APPLICATION NO.	FILING DATE	FIRST NAMED INVENTOR	ATTORNEY DOCKET NO.	CONFIRMATION NO.
10/602,345	06/23/2003	Andres F. Zuluaga	12258-029001	1603
26161	7590	10/13/2006	EXAMINER	
FISH & RICHARDSON PC P.O. BOX 1022 MINNEAPOLIS, MN 55440-1022			SOLANKI, PARIKHA	
			ART UNIT	PAPER NUMBER
			3737	
DATE MAILED: 10/13/2006

<b>Office Action Summary</b>	<b>Application No.</b>	<b>Applicant(s)</b>	
	10/602,345	ZULUAGA ET AL.	
	<b>Examiner</b>	<b>Art Unit</b>	
	Parikha Solanki	3737

## DETAILED ACTION

(Source: Moreno et al, US Pub No. 2001/0047137)

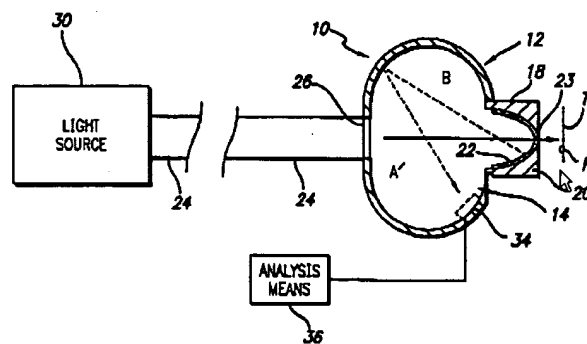
Regarding claim 2, Moreno ('137) shows a jacket encasing the optical fiber(s) (Figure 15).

(Source: Moreno et al, US Pub No. 2001/0047137)

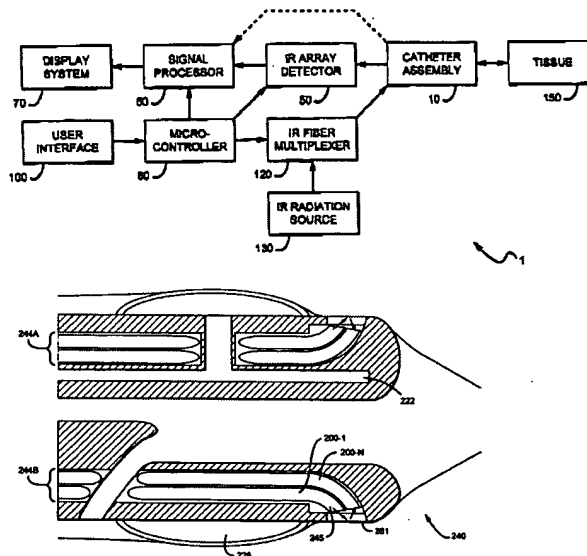
Regarding claims 10-11, Moreno ('137) discloses an atraumatic coupler comprising a lens mounted on the distal end of the fiber-optic probe (Figure 1).

(Source: Casscells ('071), Figures 1 & 20c )

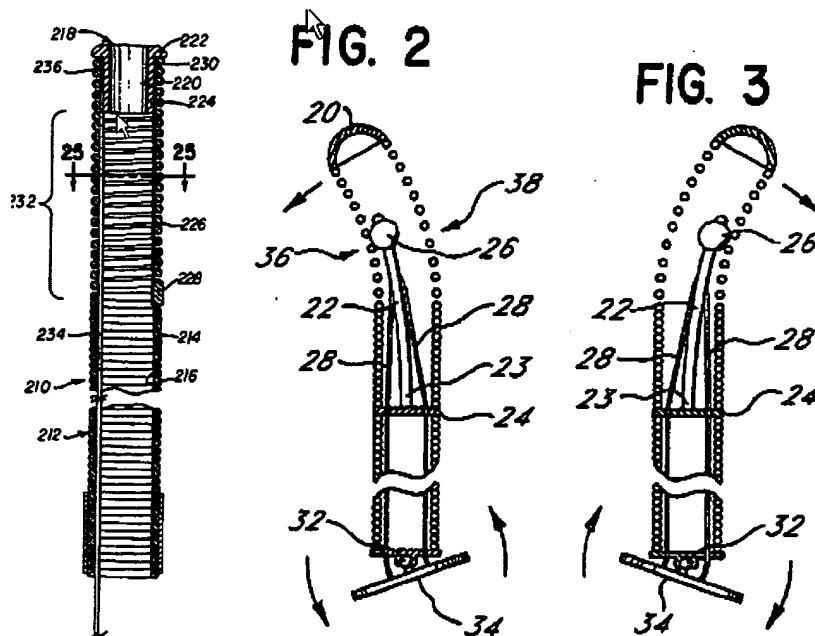
Regarding claim 46, Casscells ('071) discloses a probe having an optical fiber extending therethrough, a means for atraumatically contacting and optically communicating with the intraluminal wall, a light source in optical communication with the fiber for illumination, and a detector in optical communication with the fiber (Figs 1 & 20c).

(Source: Derbin ('021) Figure 4a)

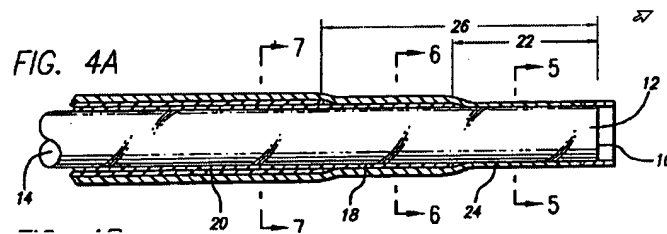
18. Claim 4 is rejected under 35 U.S.C. 103(a) as being unpatentable over Moreno ('173) in view of Hammerslag ('587) as applied to claim 3 above, and further in view of Derbin ('021). Derbin ('021) teaches the use of a variable-thickness catheter shaft in order to provide variations in stiffness along the length of the catheter, more specifically to make the distal tip more flexible than the rest of the body (Fig 4A).

(Source: Kittrell ('010) Figure 13)

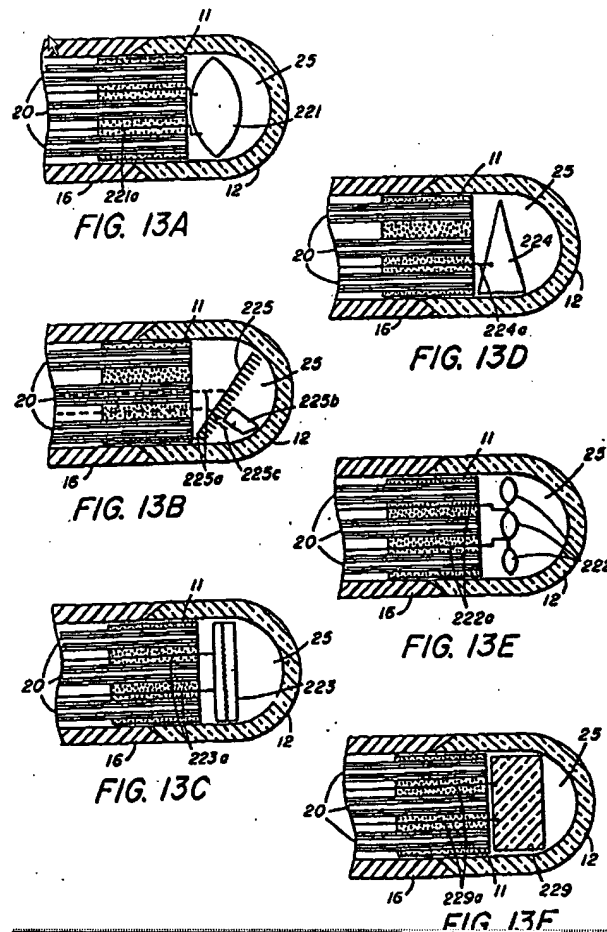
20. Claims 47-49 are rejected under 35 U.S.C. 103(a) as being unpatentable over Casscells ('071) in view of Kittrell ('010). Casscells ('071) discloses all limitations of claim 46 as described above. Casscells ('071) does not disclose a rounded distal tip or contacting the intraluminal wall. Kittrell ('010) discloses a rounded distal tip, and further discloses a lens and diffraction grating to be used at the point of illumination to better control the direction of the illuminating light (Figs 13A & 13B). Therefore, it would have been obvious to one of ordinary skill in the art at the time of invention to modify the probe of Casscells ('071) to further include a rounded surface that may also include a lens or diffraction grating to better control the direction of the illuminating light emitted by the probe assembly, in view of the teachings of Kittrell ('010).
